ANALYSIS OF EX-VESSEL STEAM EXPLOSIONS FOR THE COMBUSTION ENGINEERING SYSTEM 80+

March 1994

H. Esmaili and M. Khatib-Rahbar

Enclosure 5

Figure 6 Schematic of the CE System 80+ lower head

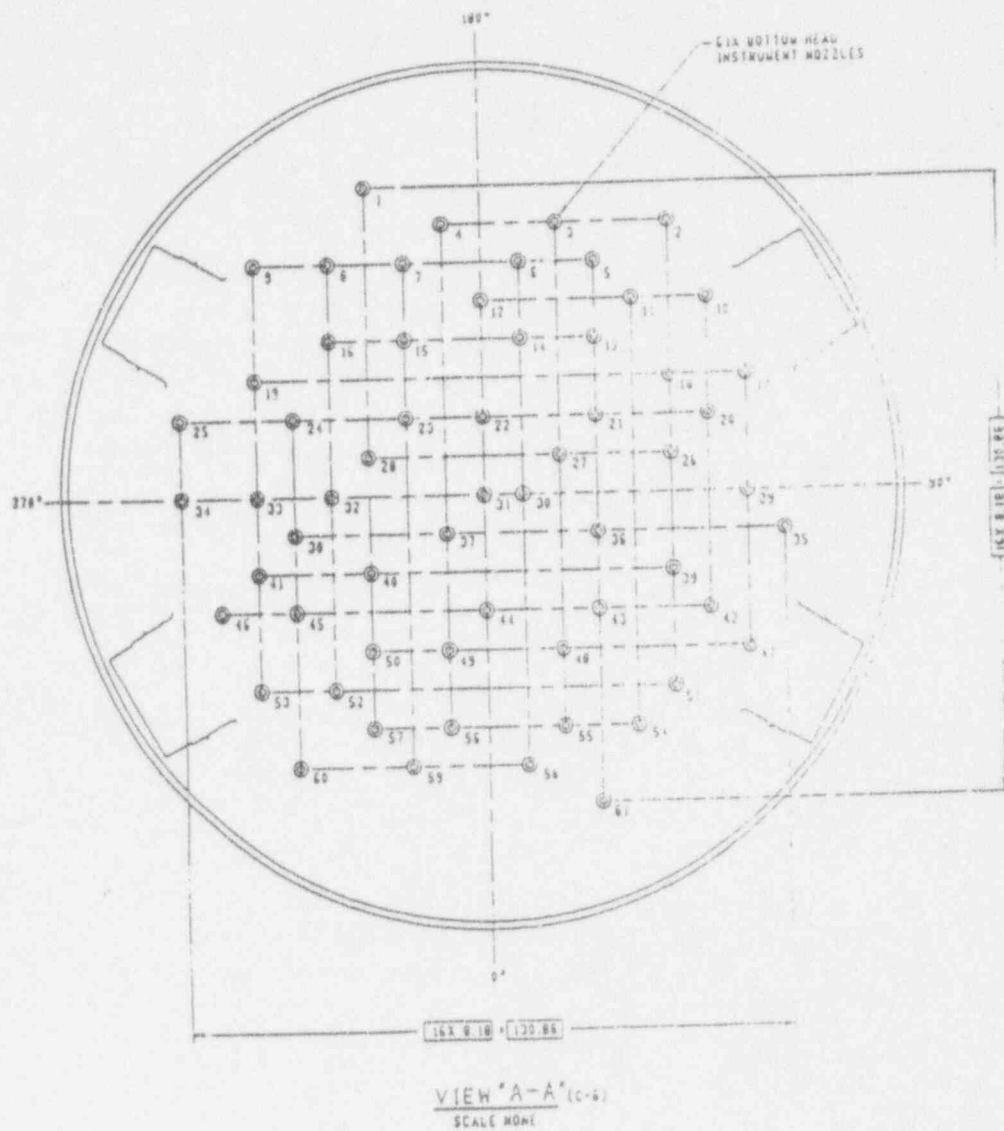
in the 5.4 m diameter vessel (page 33 of the report), **all instrument tube connections at the bottom of the vessel will be submerged** (see Figure 8). It is not clear why the instrument tube at the center of the vessel would be more likely to fail than any other instrument tube. Failure of an "outer" instrument tube may be equally likely. In that case, for the same set of parameters, a somewhat weaker explosion may result because of the lower initial melt velocity. However, the radial proximity of the failed tube to the corbel supports and cavity walls may produce significantly higher impulse loadings than a similar failure near the vessel center. Therefore, it appears that an extremely important variable, namely the radial location of the failure, has not been taken into account. Consideration of such a variable may alter the conclusions presented in the report regarding the potential impact of single instrument tube failures on the survivability of the corbel supports and cavity walls.

We have included a discussion related to the failure location of the penetration tube in the final report. If the outer instrument tubes fail (see Figure 8 in the [draft] report or Figure 6 in the final report), the loads on the corbel supports would be similar to the local impulse values, i.e., we would not expect any radial decay of the pressure and clearly some of the corbel supports in the vicinity of the instrument tube penetrations may experience higher loads.
